JR Response in green
box with black letters

**FINAL DRAINAGE REPORT
FOR
STERLING RANCH FILING NO. 4**

**November 18th 2022
Project No. 25188.11**

**PCD Filing No.:
SF-22-030**

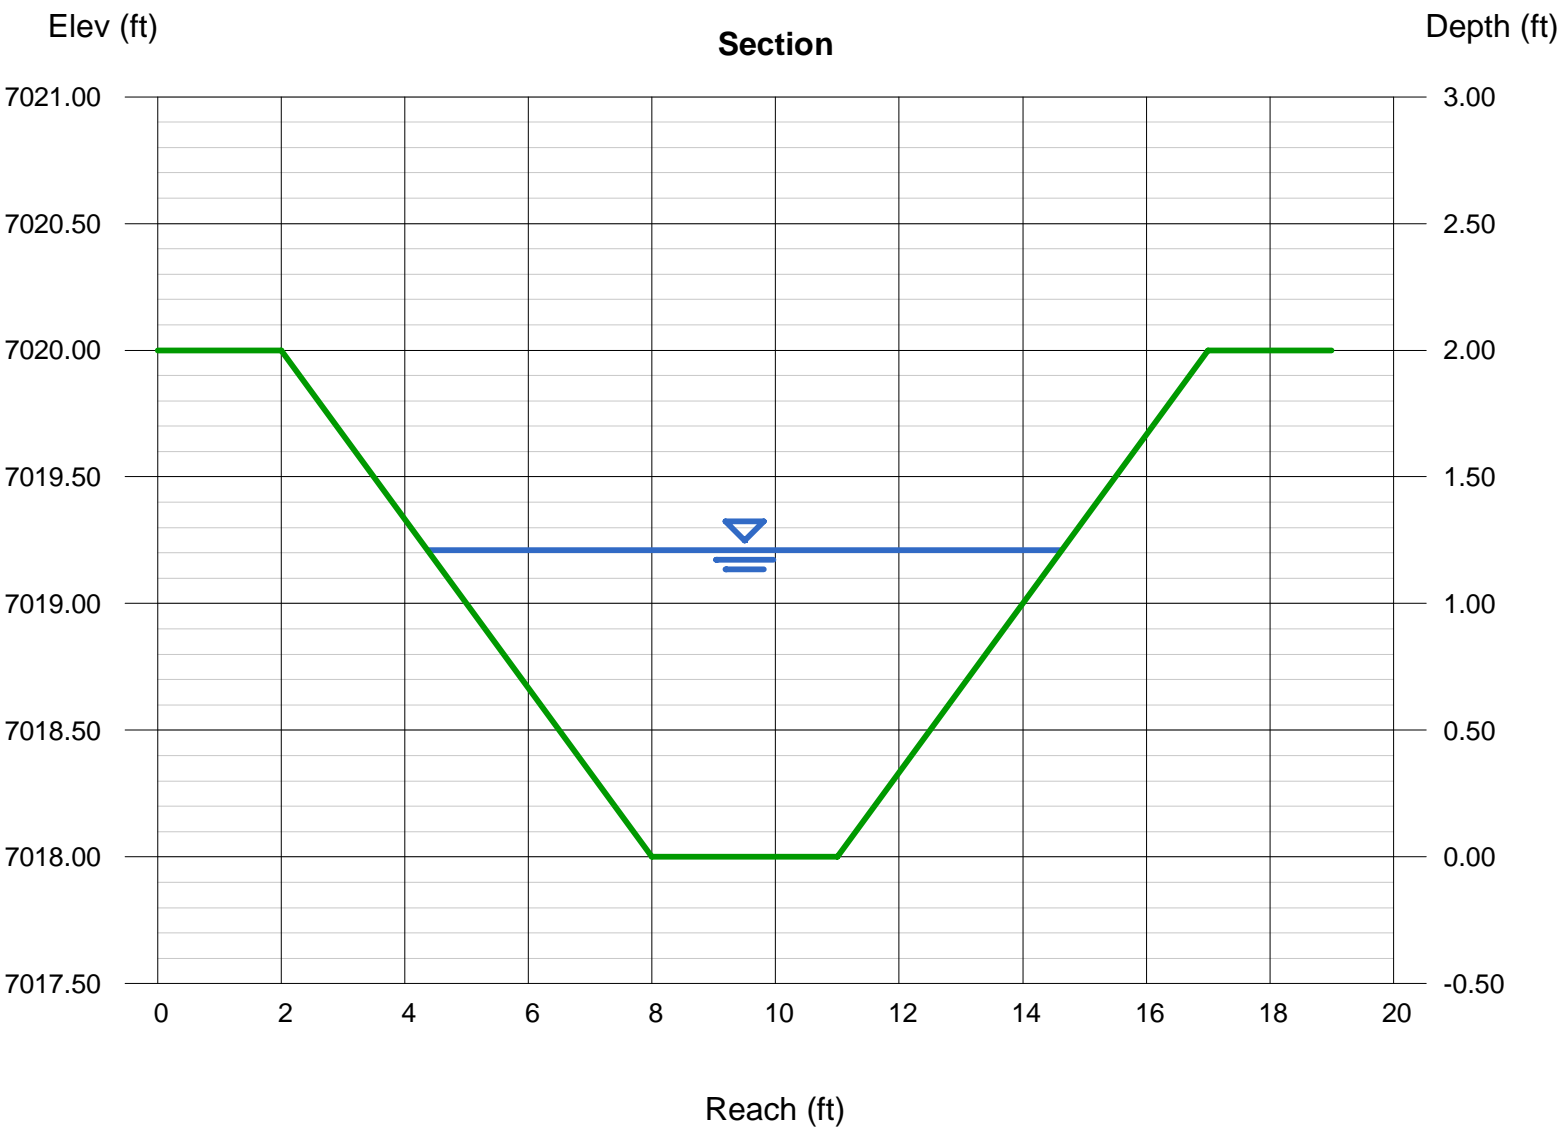
verify sizing is for overflow Q100

revised flow to be for overflow Q100

PROJECT:
ASPEN MEADOWS
FILING NO. 1
DEVELOPMENT PLAN
CITY OF COLORADO SPRINGS
JANUARY 2019

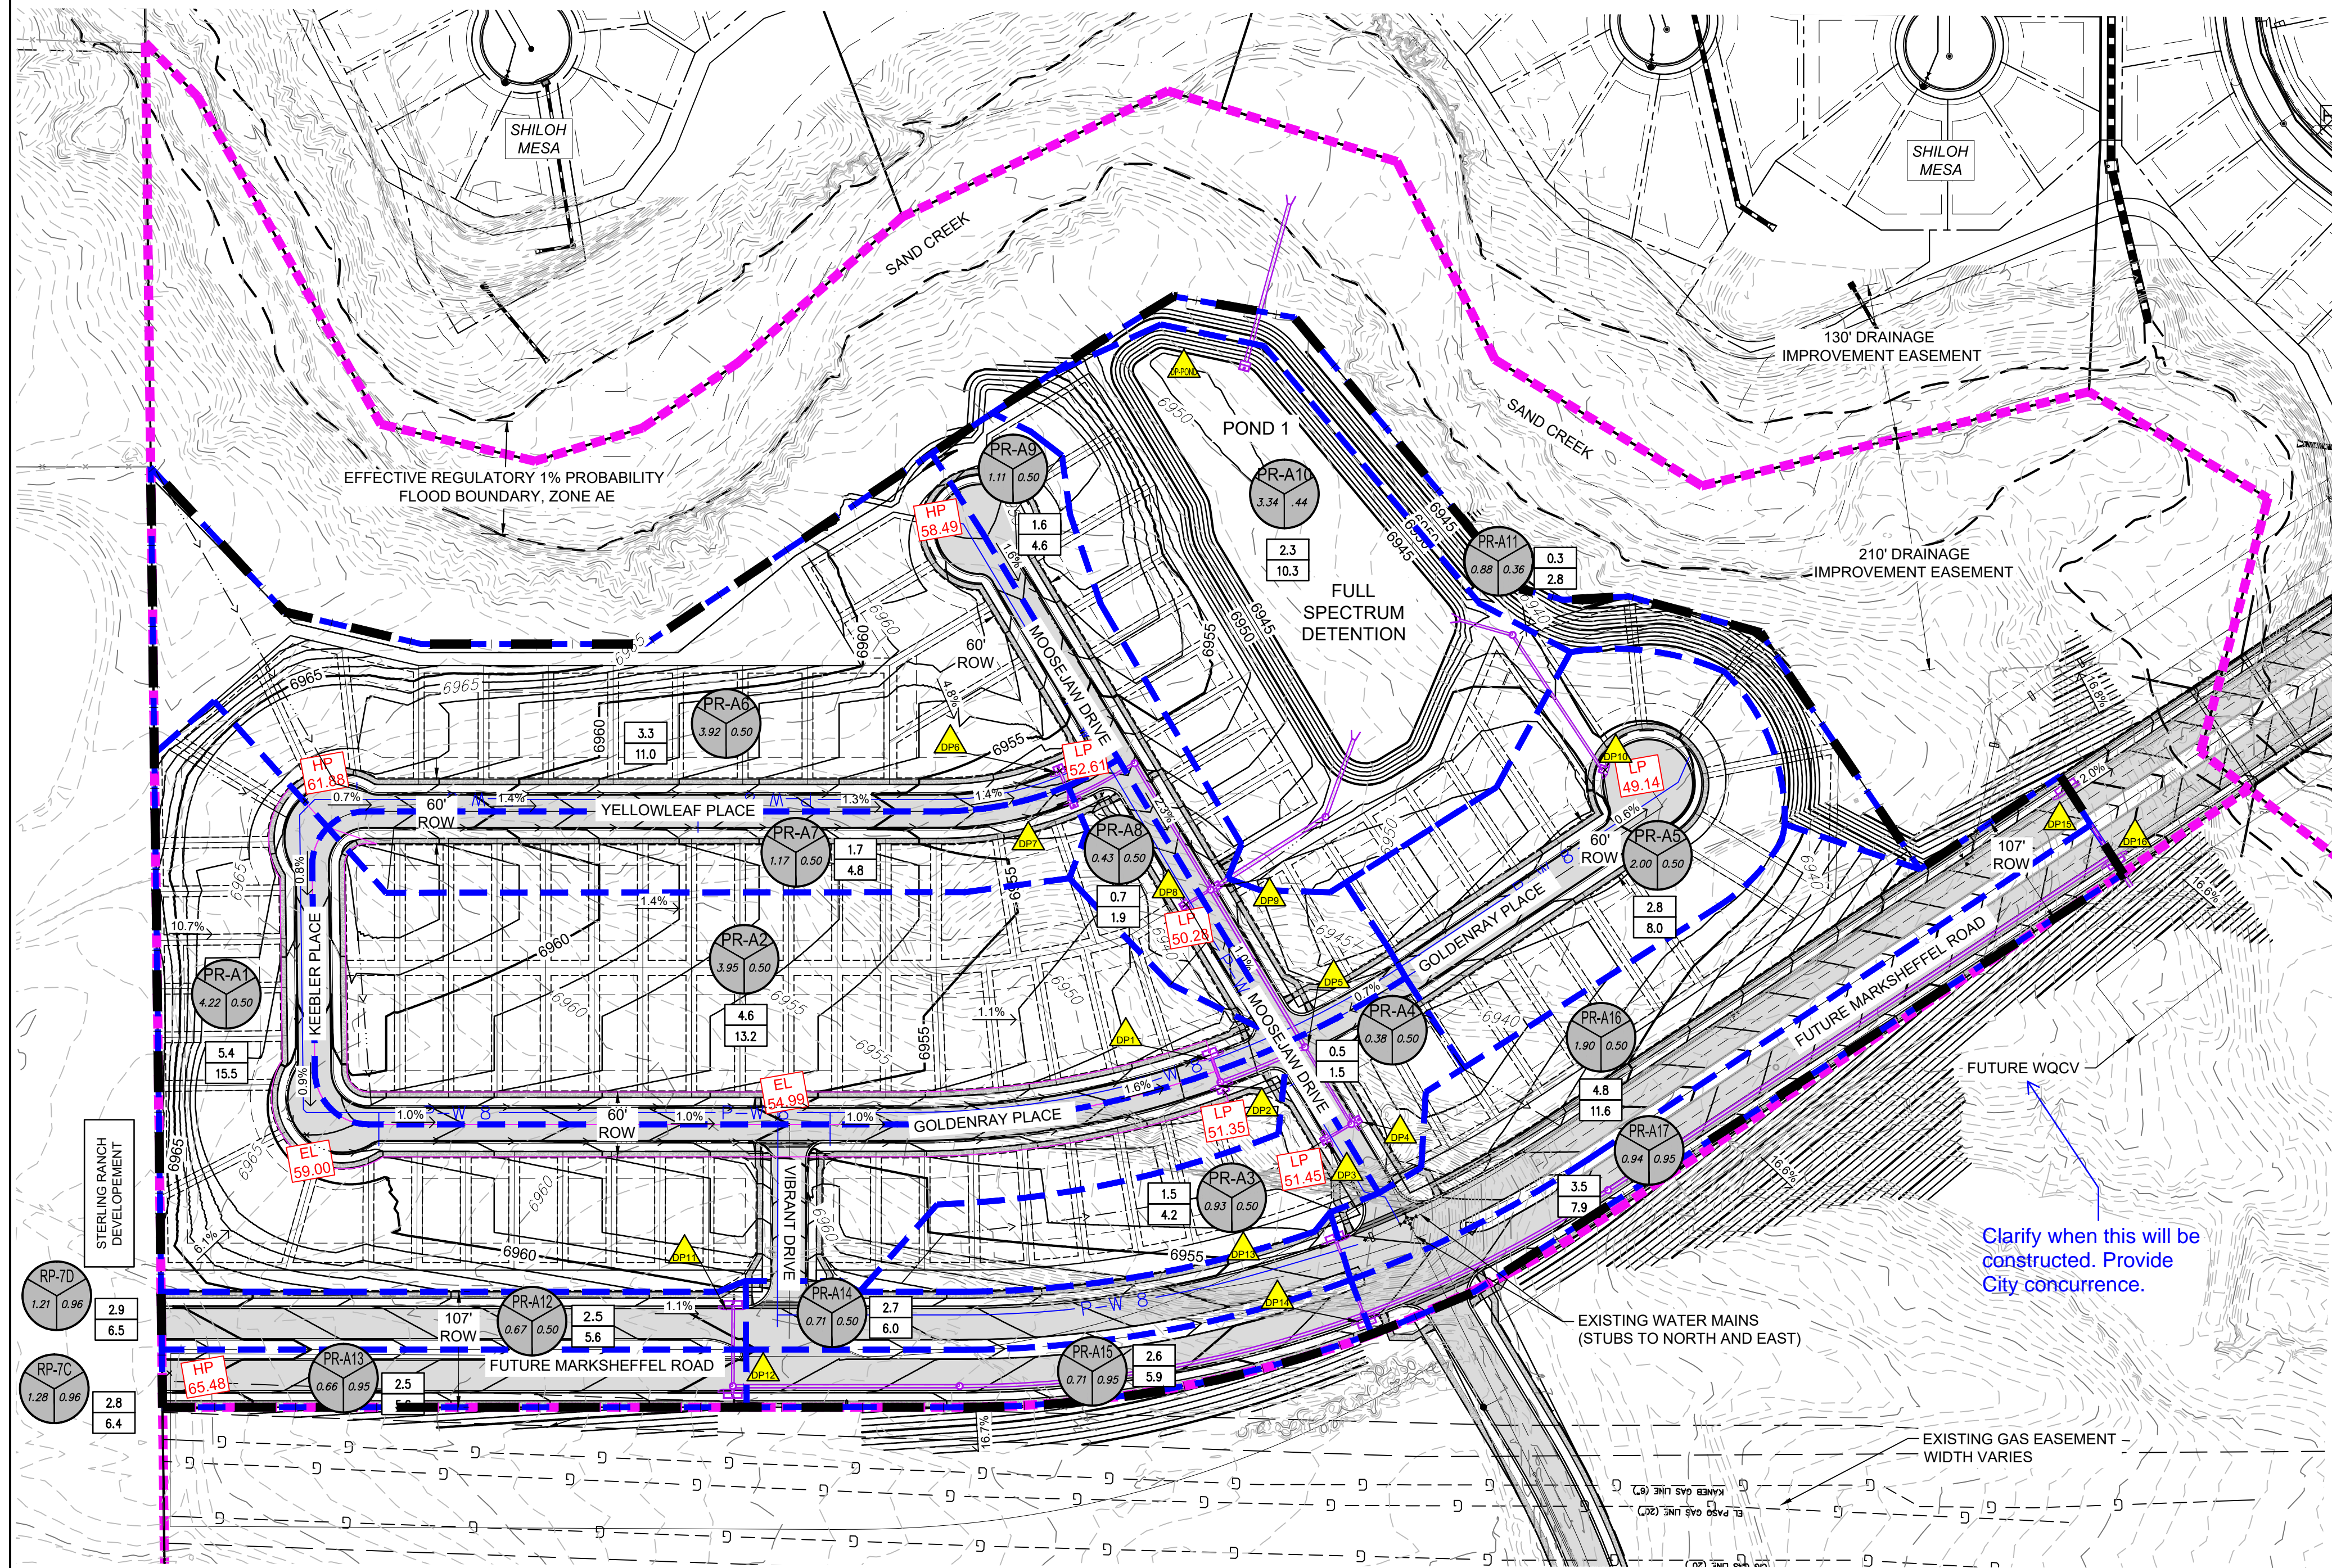
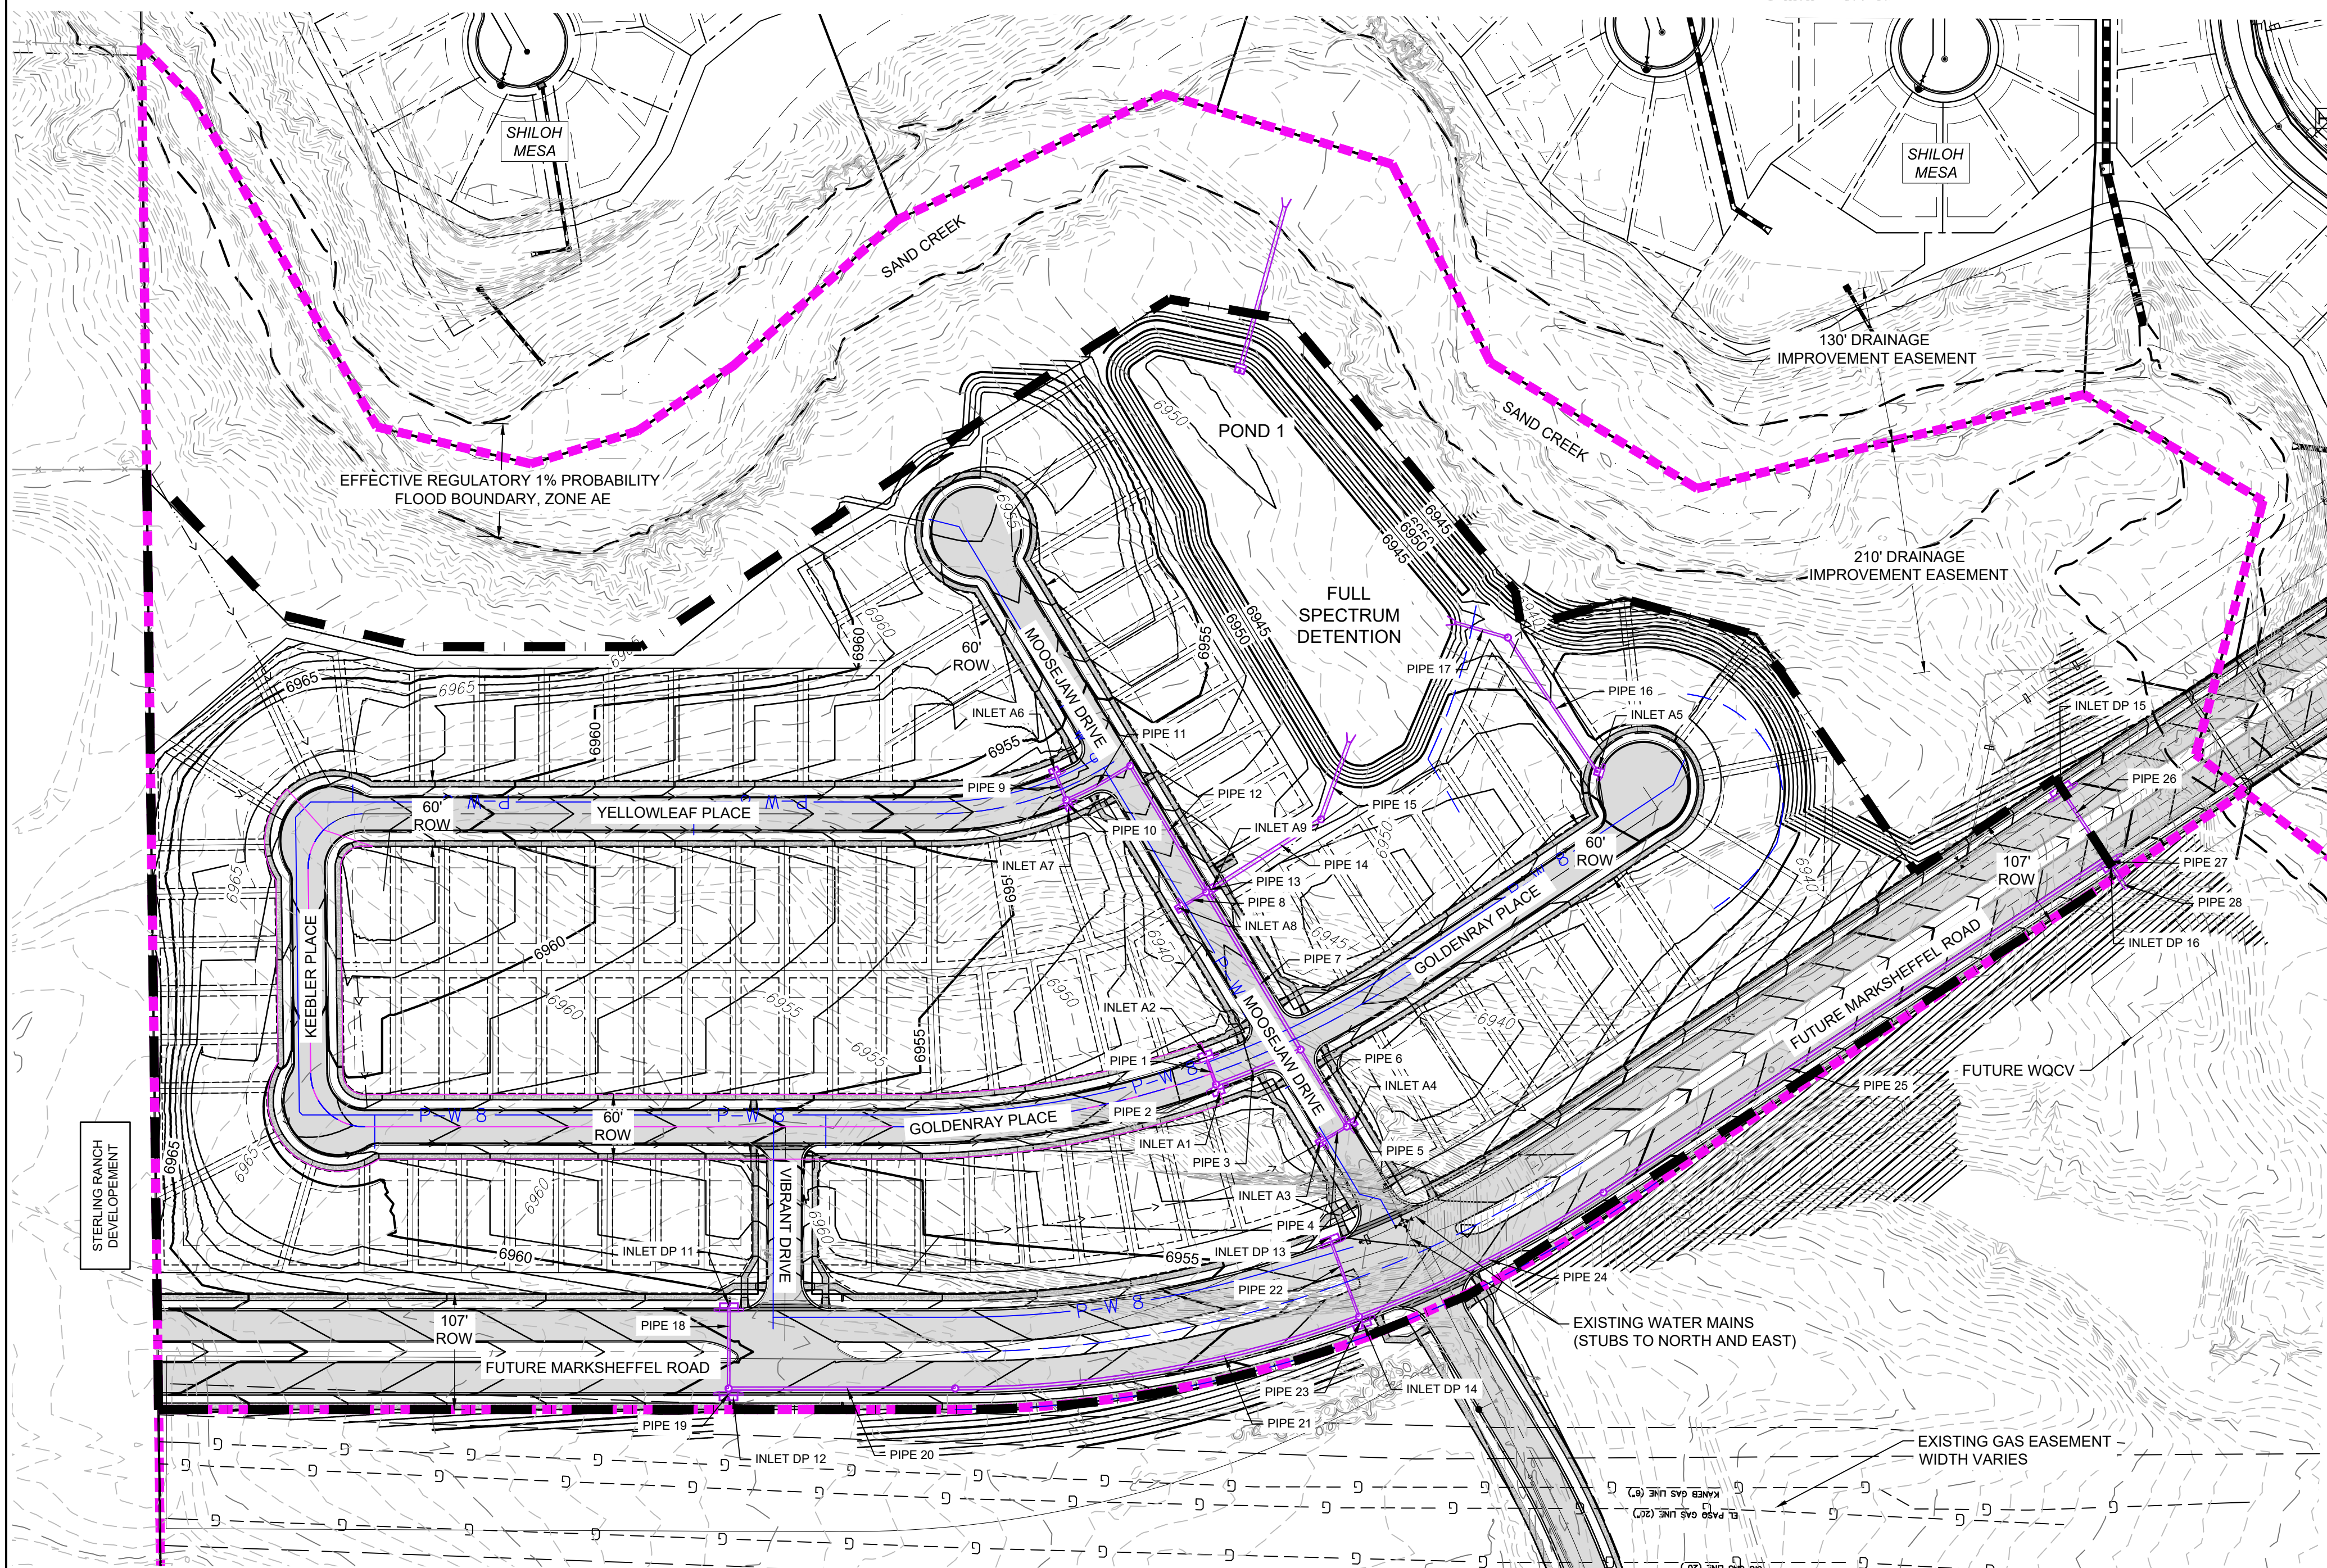
Clarify when this will be constructed. Provide City concurrence.
